**ROCKY FLATS SITE
REGULATORY CONTACT RECORD**

Purpose: Replace East Trenches Plume Treatment System (ETPTS) media and make minor changes to the piping configuration.

Contact Record Approval Date: 9/15/09

EXISTING CONDITION SITE PLAN

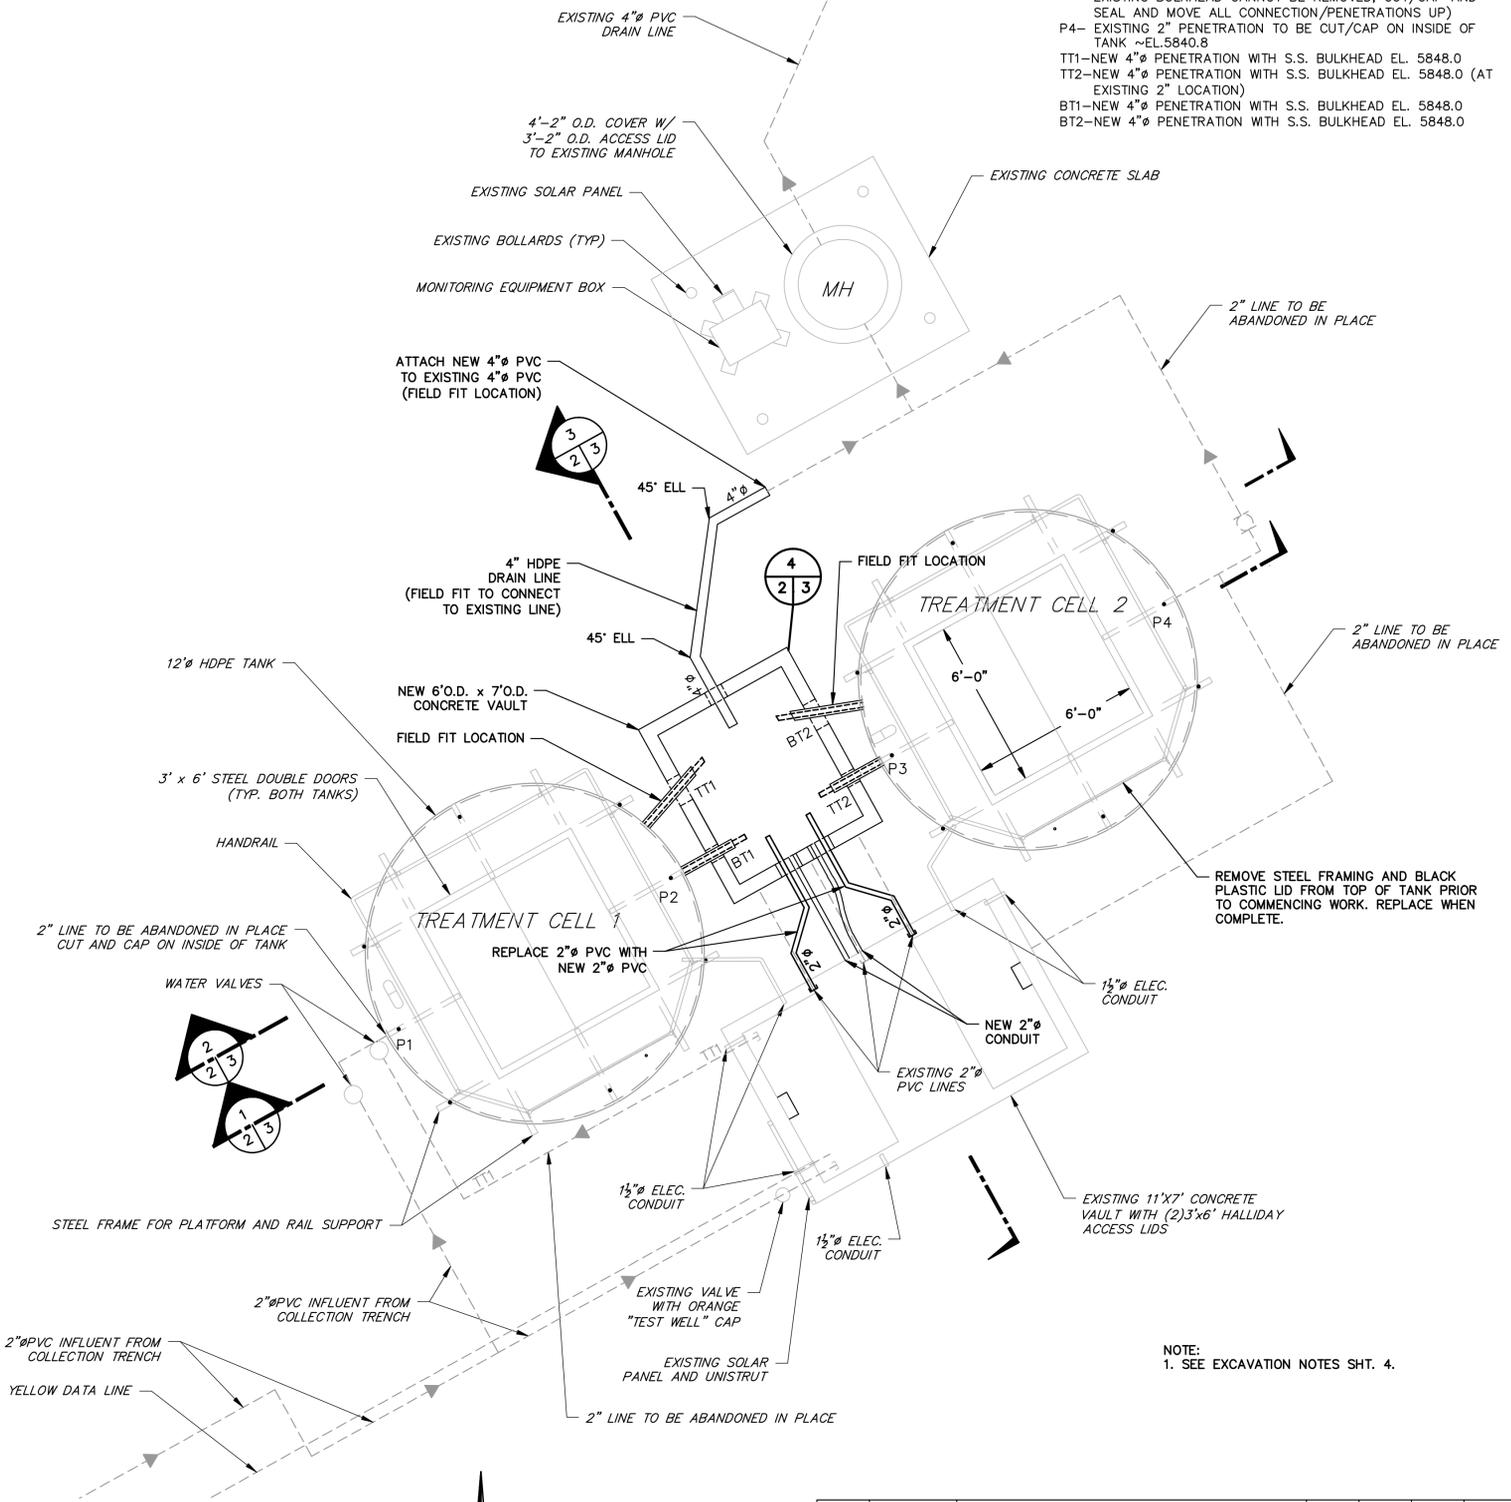
As part of this minor change to the piping configuration, a new concrete vault (approximately 6 feet wide by 7 feet long and 6 feet deep) will be installed between the two treatment cells to house the terminal ends of the piping from the cells. Removable piping sections with watertight couplings will be used within this vault to connect the pipes supporting each treatment cell to establish the desired flow configuration. Designing these pipes to be easily removable will facilitate potential maintenance needs, such as unclogging pipes. The influent lines will pass through the new vault before entering the treatment cells, and the effluent lines will pass through the new vault before flow is routed to the existing effluent manhole. A copy of the design drawing showing the plan view of the existing configuration and the new vault and piping is included as Attachment 1.

- NOTE:**
- P1- EXISTING 2" PENETRATION TO BE CUT/CAP ON INSIDE OF TANK ~EL.5848
 - P2- EXISTING 2" PENETRATION TO BE CUT/CAP ON INSIDE OF TANK ~EL.5840.8
 - P3- EXISTING 2" PENETRATION TO BE REMOVED AND NEW 4" PIPE/BULKHEAD INSTALLED OVER EXISTING LOCATION (I.E. ENLARGE THE CELL PENETRATION TO SUPPORT THE NEW BULKHEAD BY RE-CORING THE HDPE CELL) ~EL.5848 (IF EXISTING BULKHEAD CANNOT BE REMOVED, CUT/CAP AND SEAL AND MOVE ALL CONNECTION/PENETRATIONS UP)
 - P4- EXISTING 2" PENETRATION TO BE CUT/CAP ON INSIDE OF TANK ~EL.5840.8
 - TT1-NEW 4" PENETRATION WITH S.S. BULKHEAD EL. 5848.0
 - TT2-NEW 4" PENETRATION WITH S.S. BULKHEAD EL. 5848.0 (AT EXISTING 2" LOCATION)
 - BT1-NEW 4" PENETRATION WITH S.S. BULKHEAD EL. 5848.0
 - BT2-NEW 4" PENETRATION WITH S.S. BULKHEAD EL. 5848.0
